## Annotated Marked Up Drawings

## **Remarks Regarding Claims**

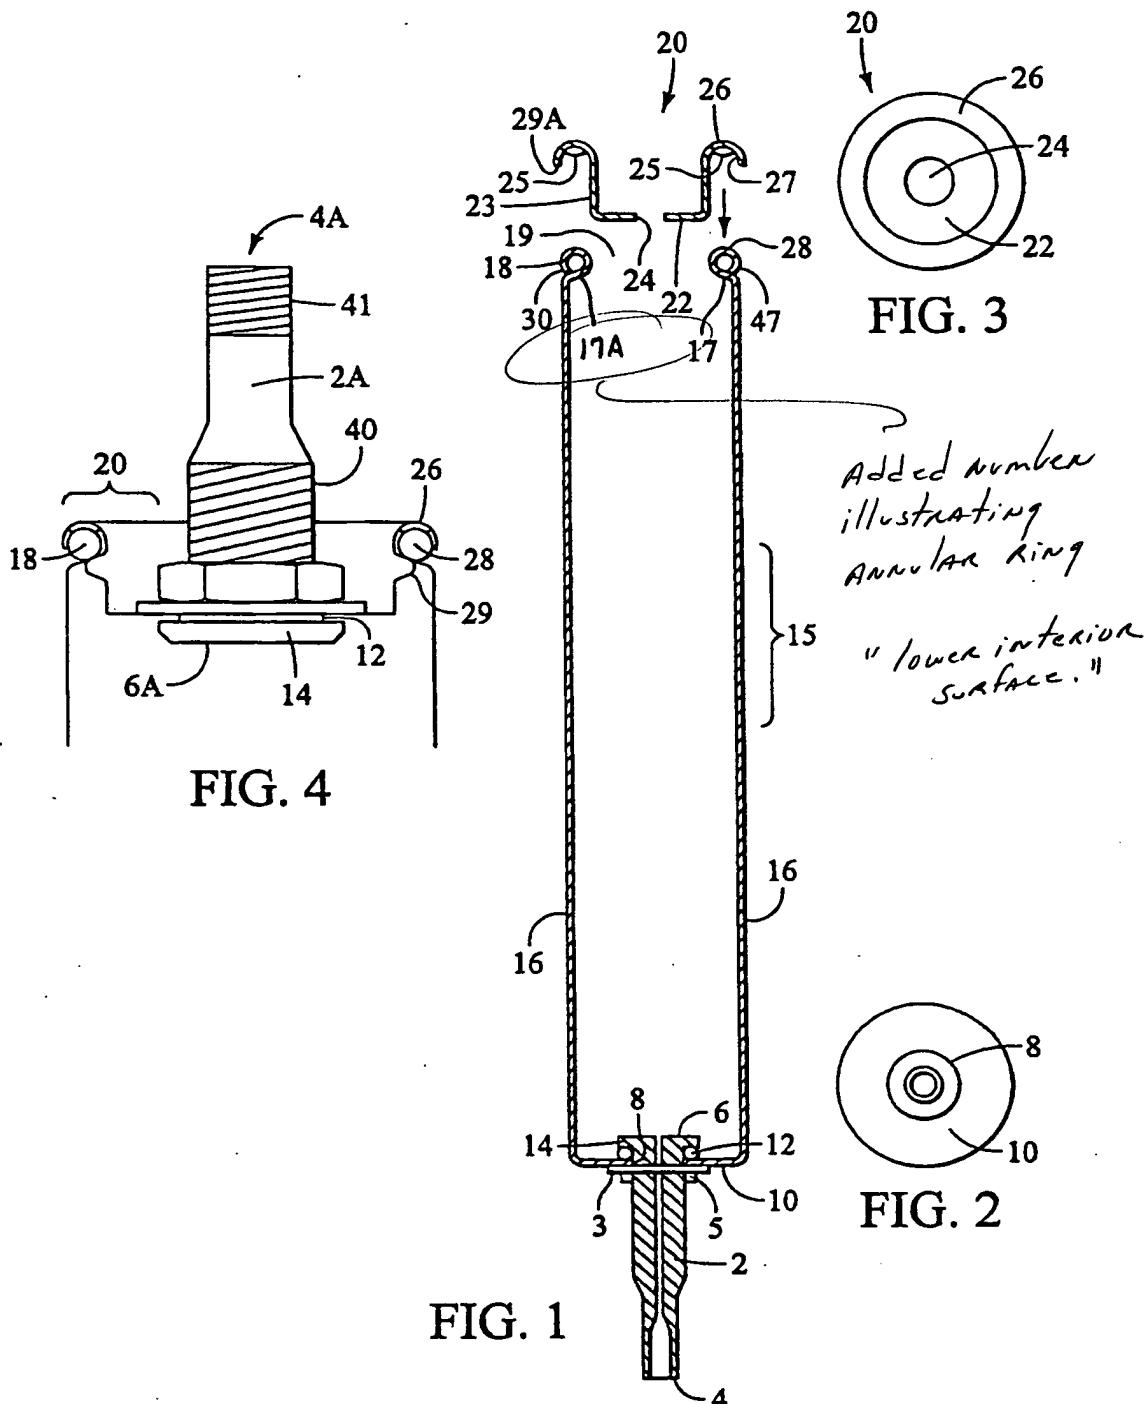
The applicant has amended the specification merely to reflect the changes in the descriptive language used in the claims with one exception. The applicant is now reciting 17A to be the annular ring lower internal surface. This occurs on page 9 of this paper four lines above the beginning of the second paragraph.

The drawing has been amended to show the location of Item 17A. Please see the annotated drawing for the location.
